IN THE MATTER OF THE APPLICATION OF WATER UTILITY OF GREATER TONOPAH, INC., AN ARIZONA CORPORATION, FOR AN EXTENSION OF ITS EXISTING CERTIFICATE OF CONVENIENCE AND NECESSITY.	Docket No. W-02450A-06-0626
IN THE MATTER OF THE APPLICATION OF HASSAYAMPA UTILITY COMPANY, INC., AN ARIZONA CORPORATION, FOR AN EXTENSION OF ITS EXISTING CERTIFICATE OF CONVENIENCE AND NECESSITY.	Docket No. SW-20422A-06-0566 **Notice of Filing (Compliance) (ATC for Campus No. 1 WRF)**

Hassayampa Utility Company, Inc. ("HUC") respectfully files the Interim Approval To Construct ("ATC") for HUC's Campus No. 1 Water Reclamation Facility, as required under Decision No. 70357 (May 16, 2008).

II. Overview of ATC for the Phase I treatment plant ATC.

DESIGNED: MJA/DMK
DRAWN: MOA/PB CHECKED: BPM
DATE: 05-30-08
DWG. NO. M18
SHEET 38 OF 61

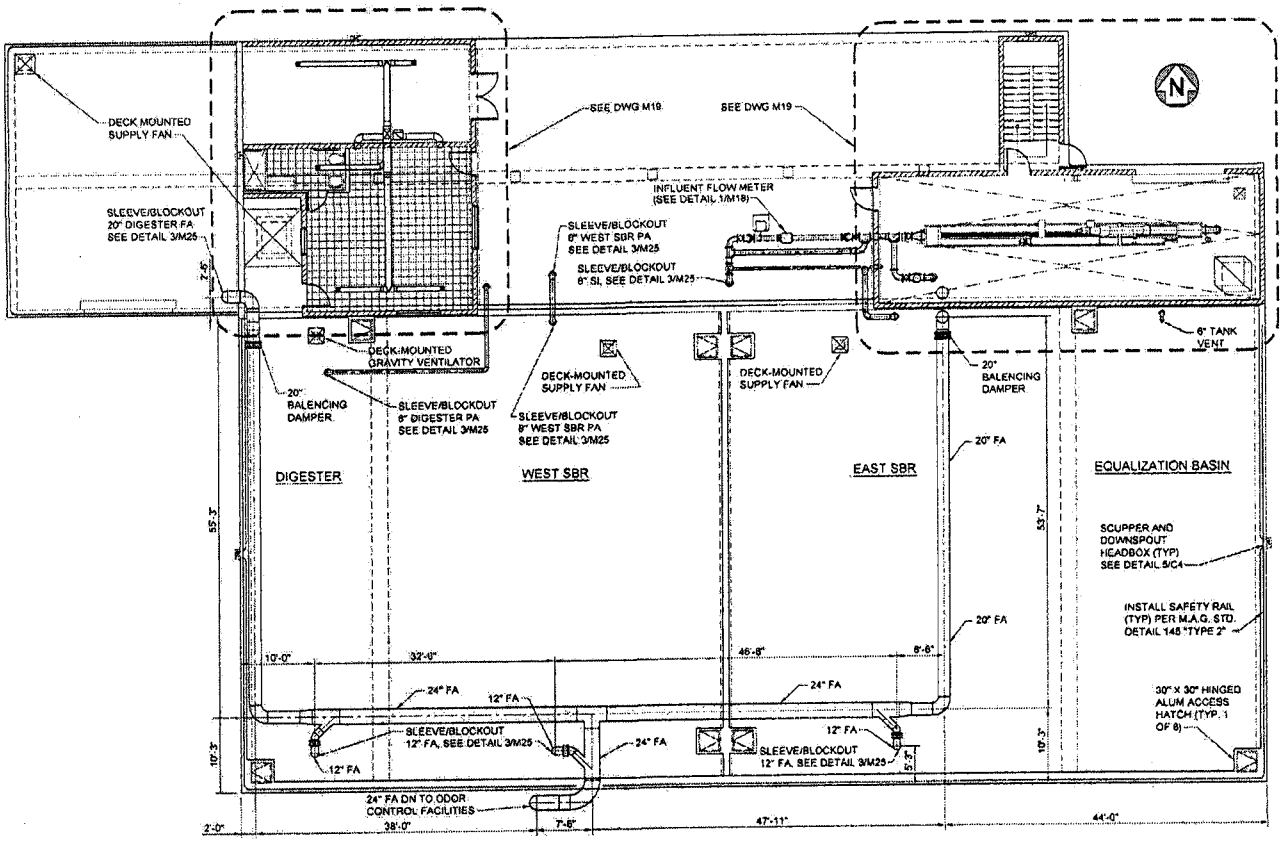
18. *M3: An overall mechanical layout drawing showing the top of the Main Process Structure (similar in scope/scale to Dwg. S4) is needed to show:*

Please see Drawing M18.
